APPLICANT:	Sammy Luke Ware		PETITION No.:	V-16
PHONE: 770-427-8240		DATE OF HEARING:	02-13-13	
REPRESENTATIVE: Sammy Luke Ware		PRESENT ZONING:	R-20	
PHONE:		770-427-8240	LAND LOT(S):	488, 549
TITLEHOLDER: Sanford Luke Ware			DISTRICT:	19
PROPERTY LOCATION: On the east side of Powder			SIZE OF TRACT:	7.53 acres
Springs Road, north of Milford Church Road			COMMISSION DISTRICT:	4
(1055 D 1 0	·	1)

TYPE OF VARIANCE:1) Waive the minimum frontage of a residential lot from the required 75 feet to zero feetto allow two homes off a private easement; 2) waive the required side setback for an accessory structure over 650square feet (existing 1,110 square foot "out building") from the required 100 feet to 20 feet on the southern side; and3) allow an accessory structure (existing 1,110 square foot "out building") to the side of the principal building.

COMMENTS

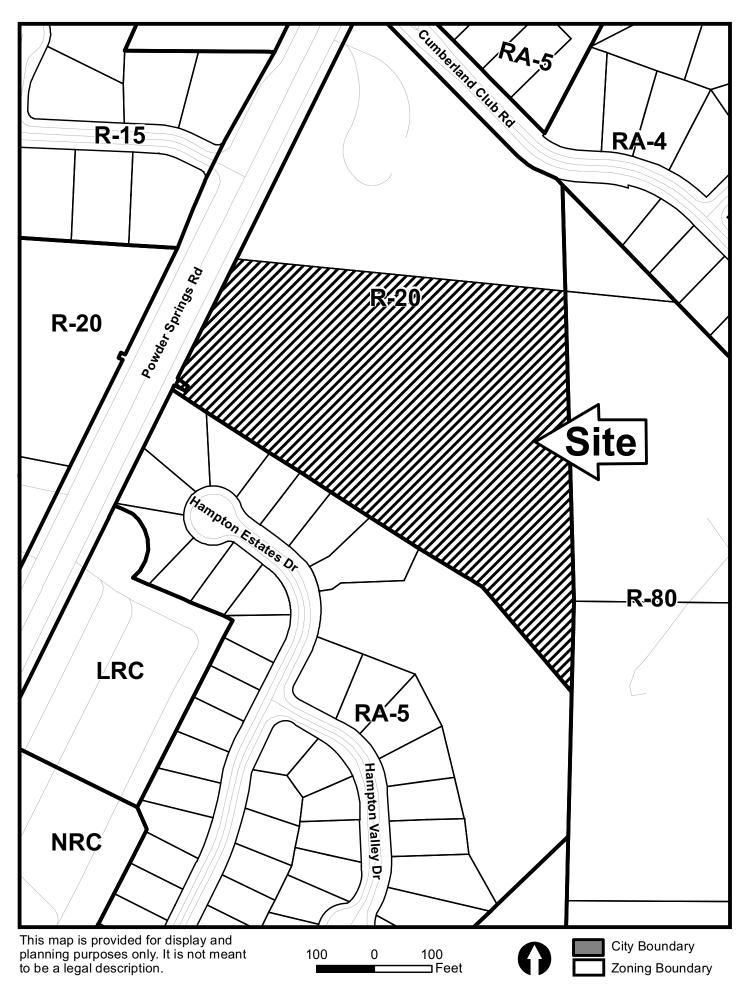
SITE PLAN REVIEW: If this variance request is approved, a subdivision plat must be recorded prior to the issuance of any building permits. Plat review may determine that there is a need for a land disturbance permit.

WATER: Water services for two new lots must be installed by owner/developer.

- Driveway must have a minimum 12'driving surface width (CCDS 402.07.01) with minimum 25' inside turning radius.
- Driveway must have a minimum 12'driving surface width (CCDS 402.07.01) with minimum 25' inside turning radius.

- Fully developed landscaping shall be at least 7'0" from center of drive (14'clear width) and 13'6" vertical clearance.
- Maximum grade shall not exceed 18% angle of departure shall not exceed 8.5%.

- Driveway must extend within 150' of the most remote portion of the structure.
- Driveway is limited to 1000' maximum from roadway unless an approved turn-around is provided

- a) Residential cul-de-sac without an island shall have a 38-foot outside radius. A cul-de-sac with an island reverts to the commercial standards, refer to www.cobbfire.org for dimensions.

- b) Hammerhead turn-around: total of 102 feet needed (45 ft + 12 ft drive + 45 ft) with the turn-around leg to be a minimum of 20 ft. wide.
- Driveway must support 25 Tons (50,000 lbs.)

- Provide emergency access through all gates securing Fire Dept. access with a minimum 12'-0" clear width and approved means of operation (www.knoxbox.com)

- Hydrant location within 500' of the most remote portion of the structure*
- Fire Flow Test from closest existing hydrant shall be provided meeting the minimum*

(Required Flow: 1000 gpm @ 20 psi)
